TECHNICAL SERVICE BULLETIN

TSB#: 12-007

Replace the gas line main quick disconnect valve and test.

Jay Flight; Jay Feather; Eagle
 Replace Disconnect Valve
 12-007

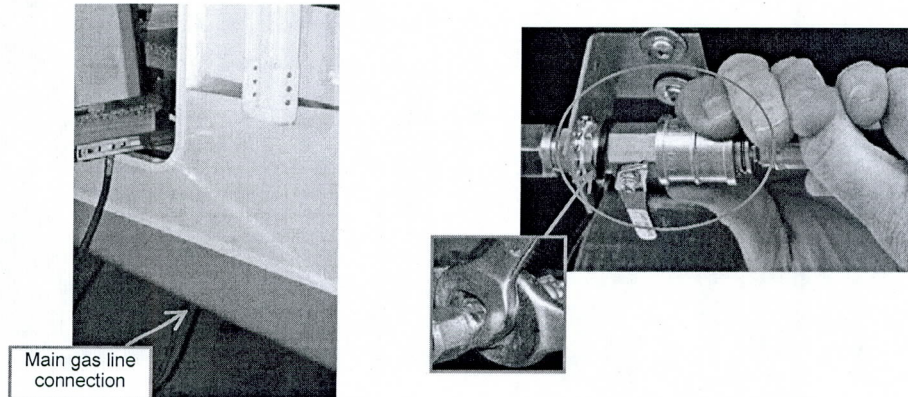
1. Close all tank valves. Make sure the quick disconnect valve is in the closed position.
2. Locate the main gas line connection. It will be located at the rear door (curb) side of the unit, behind the bottom skirt. The fitting to be replaced is the main gas line quick disconnect valve. Loosen (using 2 open 5/8" & 3/4" wrenches) the quick disconnect valve.

3. Install the new quick disconnect valve. Tighten the valve on the main gas line using the two wrench method. Make sure the connection is tight.

Set up for testing

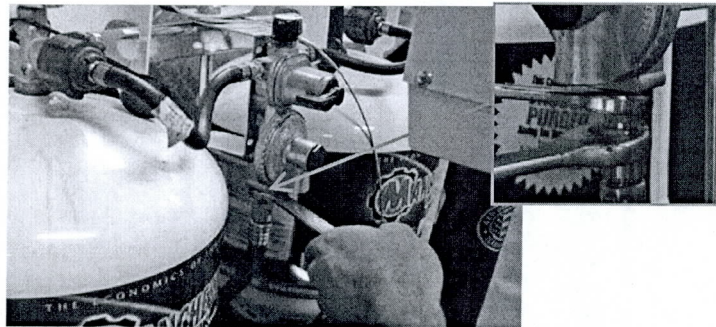
4. Close all tank valves
5. Using a 7/8" wrench, loosen and disconnect the unit gas hose from the gas regulator.
NOTE: When disconnecting the hose from the regulator, a wrench should be used to hold the regulator fitting in place. Failure to do so may cause the fitting to loosen in the regulator resulting in a gas leak.

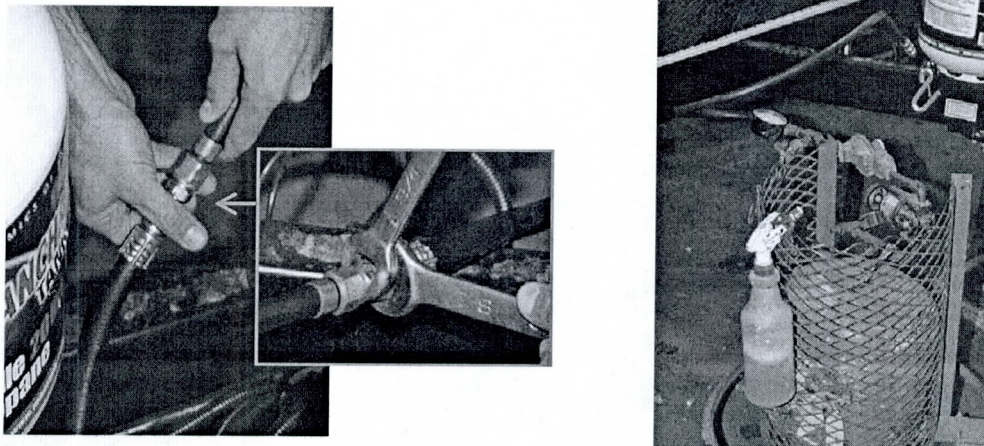
6. Hook up the unit gas hose to the appliance tester. Make sure the connection is tight.

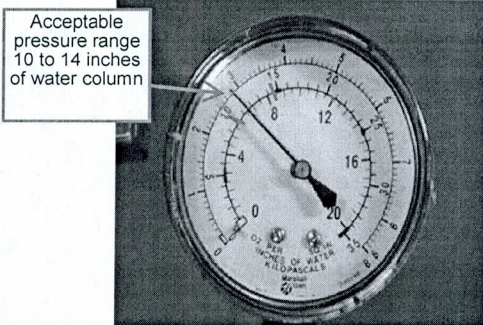
7. Open the valve on the appliance tester until the pressure is **NO LESS THAN 10 AND NO MORE THAN 14 INCHES OF WATER COLUMN.**
8. Close the tester valve. Observe the tester gauge to assure the pressures holds for a **MINIMUM OF 3 MINUTES.**

9. Use soap and water to spray the gas connections at the new quick disconnect valve. **NOTE: Do not use products that contain ammonia or chlorine.** Watch for bubbles at the connections for a **MINIMUM OF 3 MINUTES.**
 - If there are no bubbles present **AND** there is no drop in the pressure on the gauge, the connections pass the inspection. Proceed with the next step.
 - If there are no bubbles but the gauge **DID NOT** hold pressure, the leak needs to be identified and the quick disconnect valve connection re-tested.
 - If there **ARE BUBBLES** at the connection indicating a leak, tighten all of the connections. Once the connections have been tightened, **RE-TEST FOLLOWING THE PROCEDURE OUTLINED BEGINNING AT STEP 7.**
10. Disconnect the tester and re-connect the unit hose to the regulator.
